Serial: NPD-NRC-2009-111
June 15, 2009

**LEVY NUCLEAR POWER PLANT, UNITS 1 AND 2
DOCKET NOS. 52-029 AND 52-030
RESPONSE TO REQUEST FOR ADDITIONAL INFORMATION LETTER NO. 038 RELATED TO
POTENTIAL DAM FAILURES**

**Levy Nuclear Power Plant Units 1 and 2
Response to NRC Request for Additional Information Letter No. 036, May 15, 2009,
Related to SRP Section 2.4.4 for the Combined License Application**

Progress Energy Florida
**Levy Nuclear Plant
 Units 1 and 2**
 Elevation of the Withlacoochee and
 Waccasassa Drainage Basins
FIGURE 1

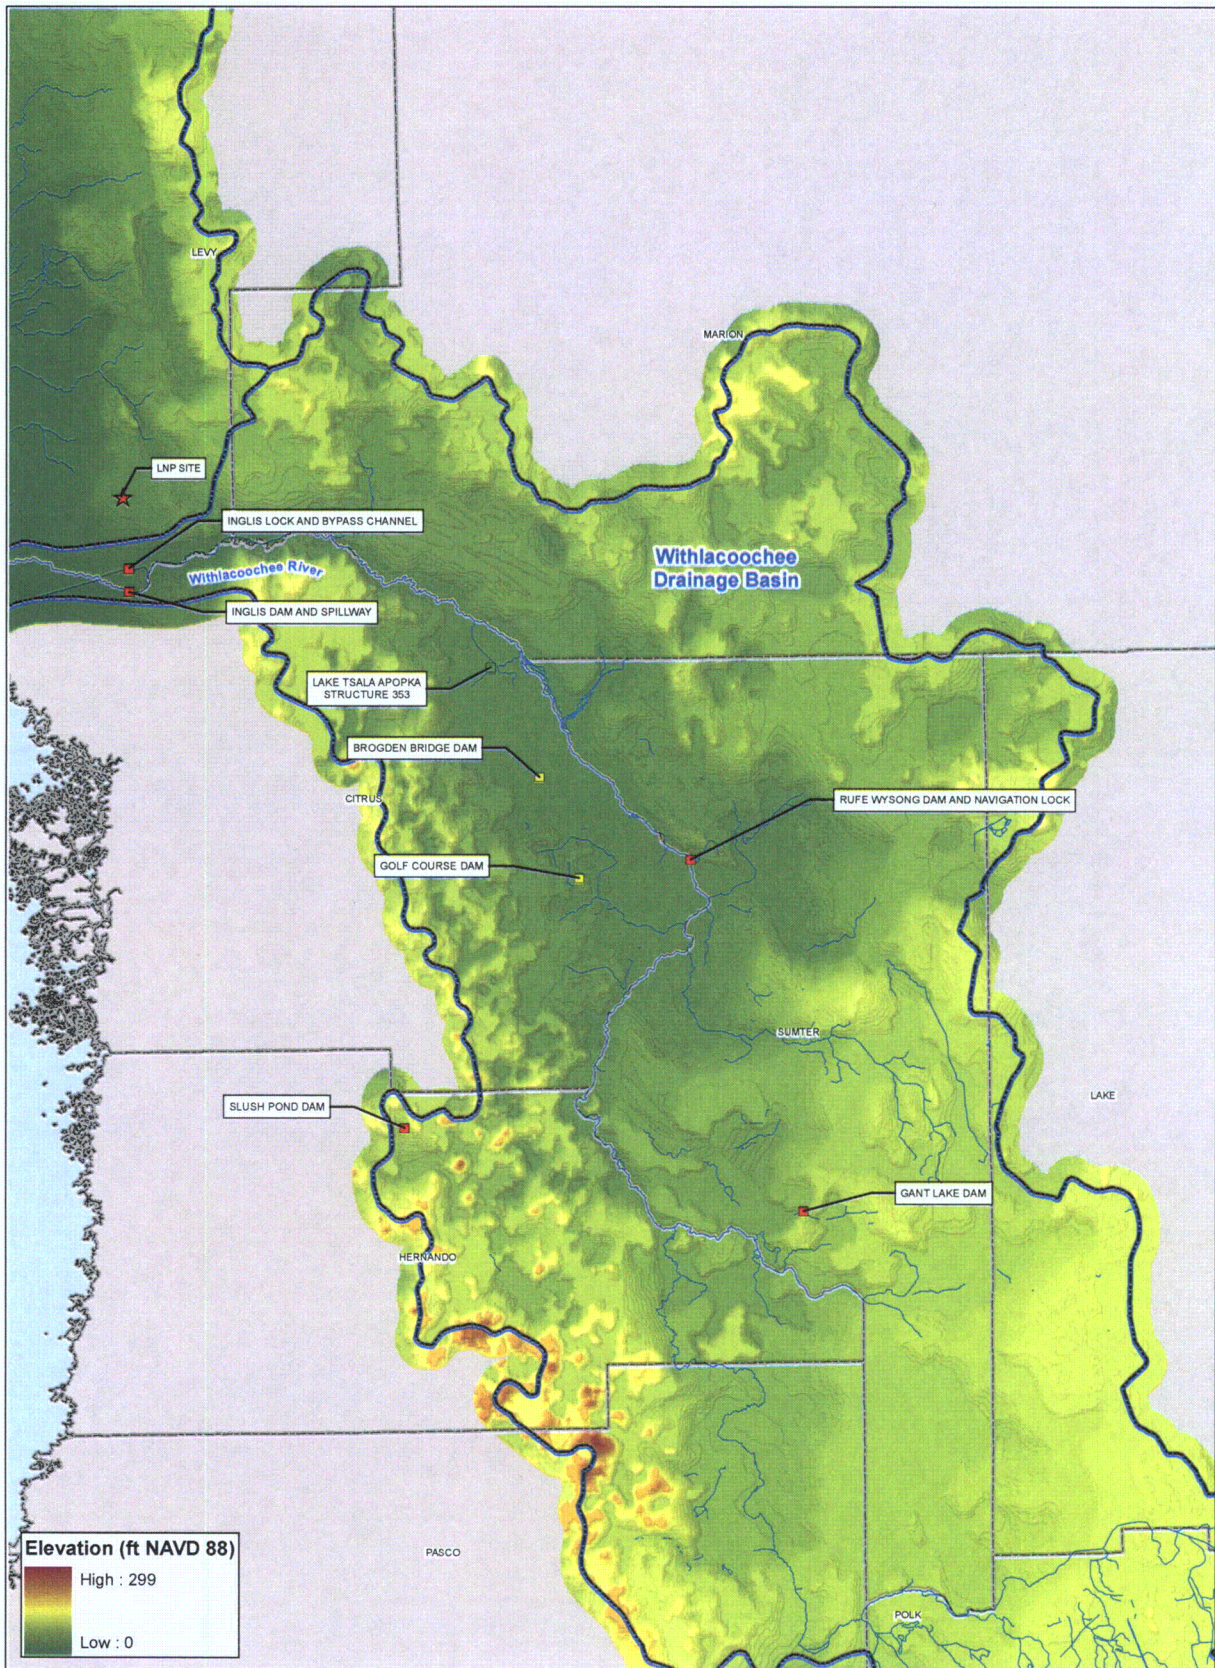
To meet the requirements of GDC 2, 10 CFR 52.17, 10 CFR Part 100, and 10 CFR 100.23(d), an appropriate configuration of the cascade of dam failures and its potential to produce the largest flood adjacent to the plant site is needed. Please clarify the description of all existing and proposed water retaining and water control structures both upstream and downstream relative to the LNP site location and justify why failure of these may not affect flood elevations near the LNP site.

The LNP site is located entirely in the Waccasassa Drainage Basin and is not on or near a water body that could potentially result in flooding of the site. As described in FSAR Subsection 2.4.1.2.9, there are no water control structures in the Waccasassa Drainage Basin (see Figure 2.4.1-212). Therefore, there are no potential hazards to the LNP site or its associated safety-related structures exist that could occur as a result of a failure of any upstream and downstream water control structures. The nearest water control structures to the LNP site are located in the Withlacoochee Drainage Basin, which is hydrologically separate from the Waccasassa Drainage Basin (see Attachment 02.04.04-2A).

This dataset was reviewed to determine characteristics of dams within the Withlacoochee Drainage Basin. The NID does not have the capability to directly identify dams by drainage basin. For this reason, GIS coverages for dams were obtained from the Florida Geographic Data Library. A GIS query was performed on the USGS Geographic Names Information System (GNIS), USGS Major Dams, and the USEPA Permitted Dam Location datasets to identify those dams that are within the Withlacoochee Drainage Basin. These dams and their

hydrologic characteristics are described in Table 1 and shown on Figure 1 (see Attachment 02.04.04-2A).

For much of its length, the Withlacoochee River meanders through a broad flat plain with very little change in elevation. A less than 1 meter change in elevation is seen through large parts of Sumter and Citrus counties (see Attachment 02.04.04-2B). The Tsala Apopka chain of lakes is an extensive water feature in the central part of the Withlacoochee Drainage Basin, which is comprised of swampland, marshes, ponds, and lakes. Features within the Tsala Apopka system are grouped into three pools: Hernando, Inverness, and Floral City. These are controlled to maintain minimum and maximum levels as described in the *Minimum and Guidance Levels for Tsala Apopka Lake in Citrus County, Florida* (Reference RAI 02.04.04-2 02).
